**SOLICITATION AMENDMENT  
MODIFICATION DE L'INVITATION**

<b>Title - Sujet</b> Boat Trailer	
<b>Solicitation No. - N° de l'invitation</b> F1705-171017/A	<b>Amendment No. - N° modif.</b> 002
<b>Client Reference No. - N° de référence du client</b> F1705-171017	<b>Date</b> 2018-01-26
<b>GETS Reference No. - N° de référence de SEAG</b> PW-\$XLV-211-7405	
<b>File No. - N° de dossier</b> XLV-7-40191 (211)	<b>CCC No./N° CCC - FMS No./N° VME</b>
<b>Solicitation Closes - L'invitation prend fin</b> <b>at - à 02:00 PM</b> <b>on - le 2018-02-05</b>	
<b>Time Zone</b> Fuseau horaire Pacific Standard Time PST	
<b>F.O.B. - F.A.B.</b> <b>Plant-Usine:</b> <input type="checkbox"/> <b>Destination:</b> <input type="checkbox"/> <b>Other-Autre:</b> <input type="checkbox"/>	
<b>Address Enquiries to: - Adresser toutes questions à:</b> Buchan, Torrey	<b>Buyer Id - Id de l'acheteur</b> xlv211
<b>Telephone No. - N° de téléphone</b> (250) 216-2092 ( )	<b>FAX No. - N° de FAX</b> ( ) -

This solicitation amendment is hereby issued to address a question posed by industry, and to provide supporting technical documents.

PROJECT		KANTER MARINE	
TITLE		10M CCG LANDING CRAFT	
DATE		4/15/15	
APPROVED		10028	
SCALE		1/2" = 1'-0"	
SHEET		1 OF 1

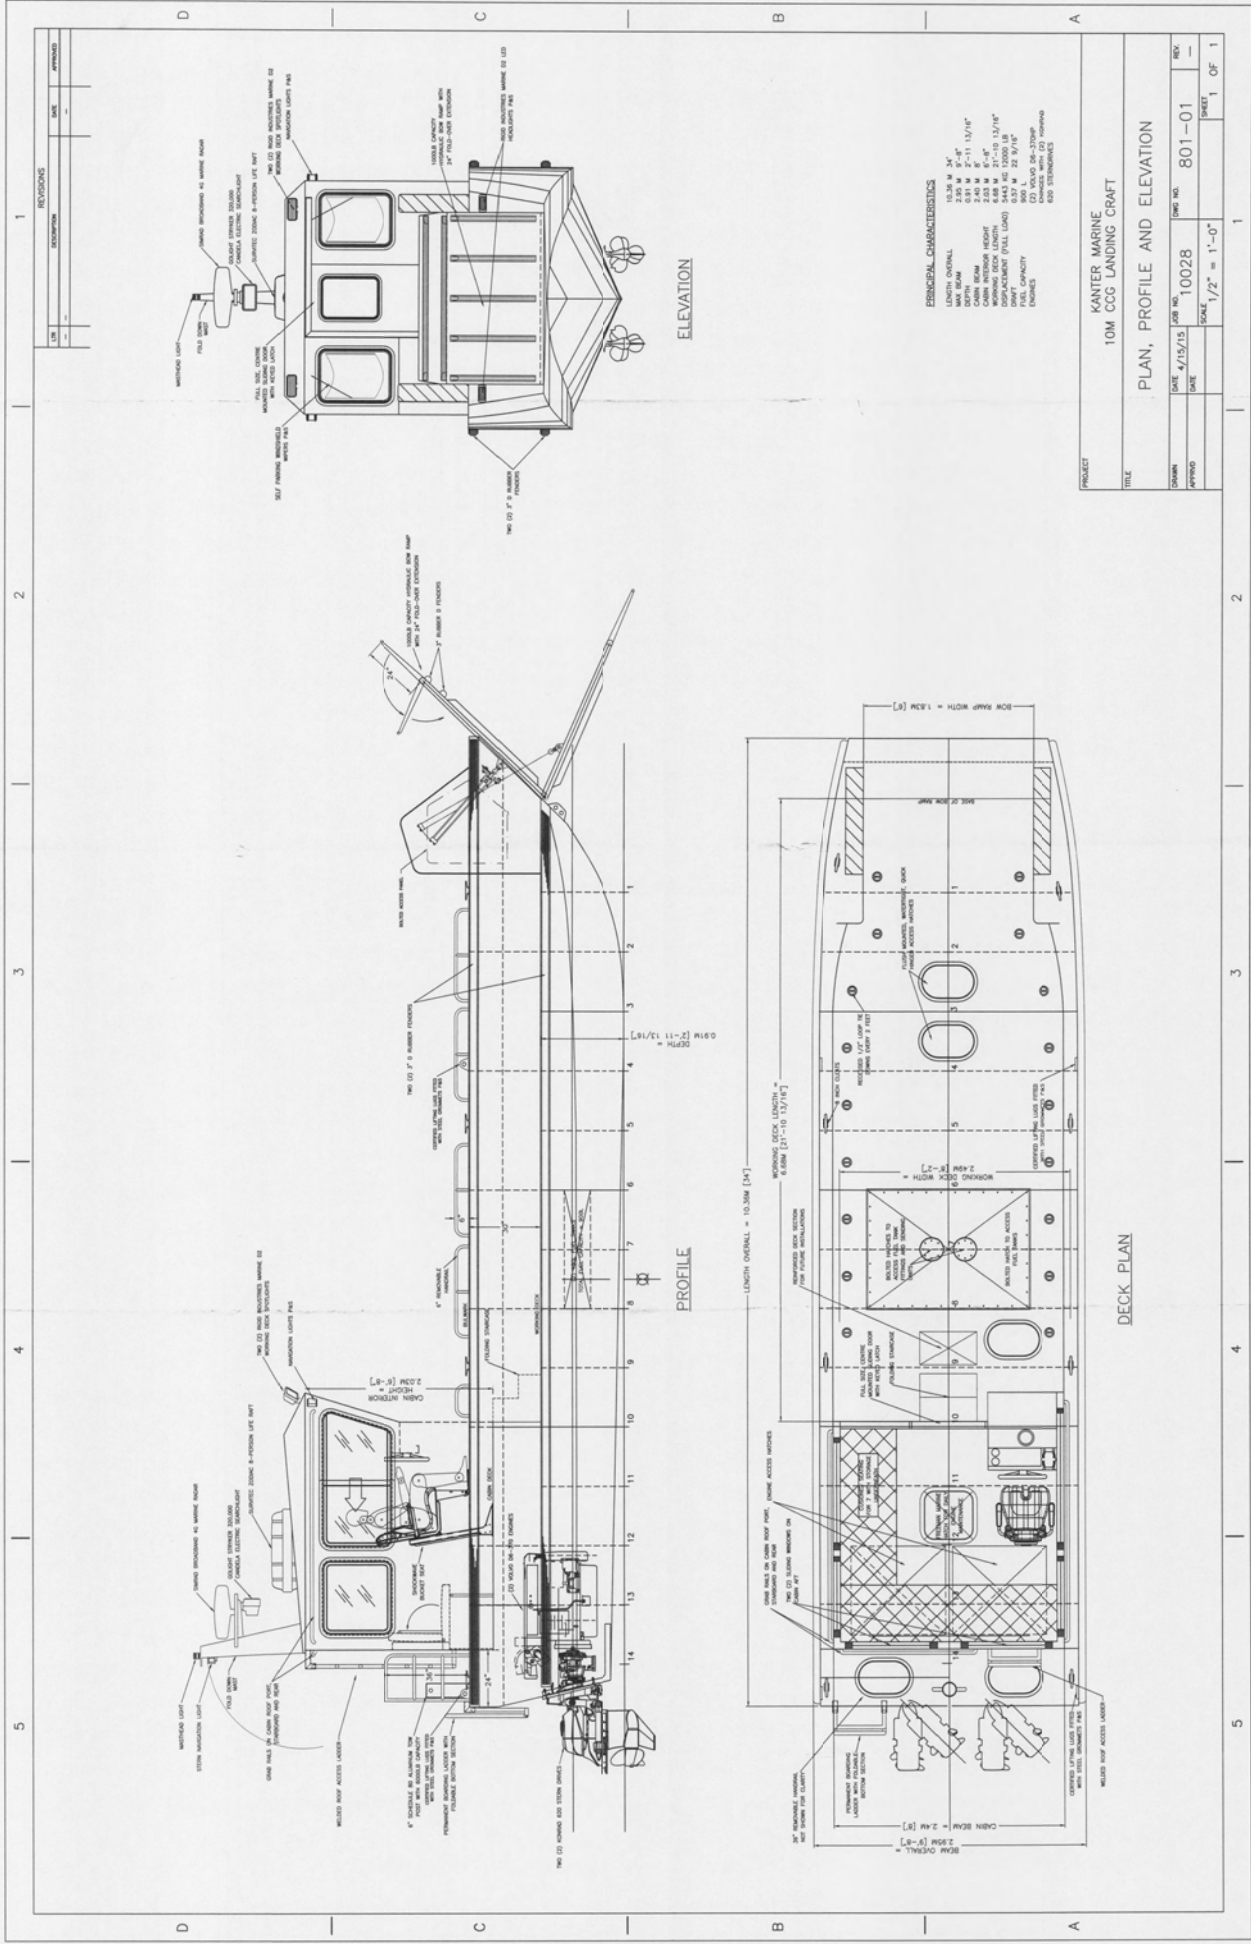
Item	Question	Answer
1	<p>This requirement includes spring suspension. Torsion is not recommended for tri-axle applications. No warranty from axle manufacturers. If the customer is willing to accept responsibility, it can be done.</p> <p>Will the Canadian Coast Guard accept responsibility for possible failed axles due to suspension type?</p>	No, the Contractor will be responsible for any possible failure of the axles due to the suspension type during the warranty period.
2	Can CCG provide drawings or photos of the landing craft?	See attached.
